Title - Sujet FLUID COOLER INSTALL	
Solicitation No. - N° de l'invitation 39903-150572/A	Amendment No. - N° modif. 002
Client Reference No. - N° de référence du client CFIA 39903-150572	Date 2015-09-25
GETS Reference No. - N° de référence de SEAG PW-\$PWU-201-10546	
File No. - N° de dossier PWU-5-38075 (201)	CCC No./N° CCC - FMS No./N° VME
Solicitation Closes - L'invitation prend fin at - à 02:00 PM on - le 2015-10-06	Time Zone Fuseau horaire Mountain Daylight Saving Time MDT
F.O.B. - F.A.B. Plant-Usine: <input type="checkbox"/> Destination: <input type="checkbox"/> Other-Autre: <input type="checkbox"/>	
Address Enquiries to: - Adresser toutes questions à: Ho (RPC), Hector	Buyer Id - Id de l'acheteur pwu201
Telephone No. - N° de téléphone (780) 901-0989 ( )	FAX No. - N° de FAX (780) 497-3510
Destination - of Goods, Services, and Construction: Destination - des biens, services et construction:

## ADDENDUM M-01

<b>Project:</b>	CFIA Dry Cooler	<b>Project No.:</b>	151-05170-00
<b>Date:</b>	September 24, 2015	<b>Client Proj. No.:</b>	H0004
<b>To:</b>	CFIA, Attn: Craig Armitage ( <a href="mailto:craig.armitage@inspection.gc.ca">craig.armitage@inspection.gc.ca</a> )		
<b>Distribution:</

**8** TYPICAL PUMP DETAIL  
M-01 SCALE: N.T.S.

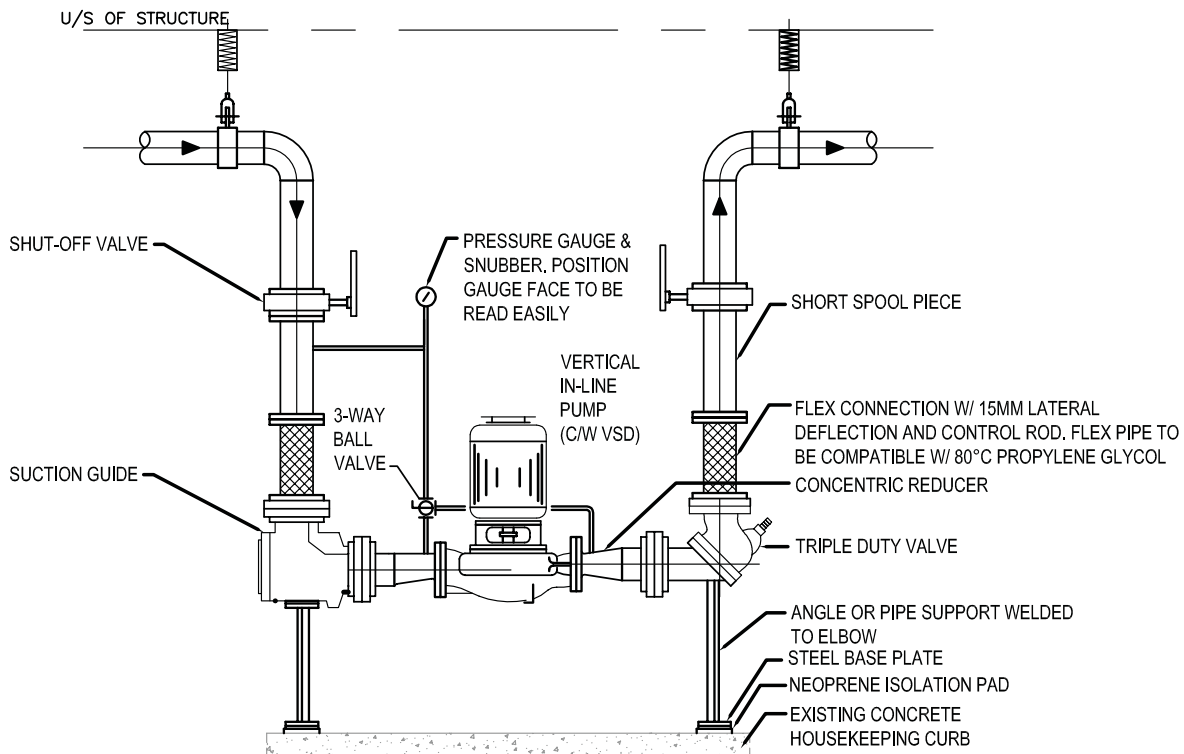
- 1.1 Pumps P-47 and P-48 shall be installed on existing housekeeping pads as per the revised typical pump detail shown in the attached mechanical sketch MSK-01. Remove inertia bases from existing pumps P-47 and P-48 prior to installation of new pumps.
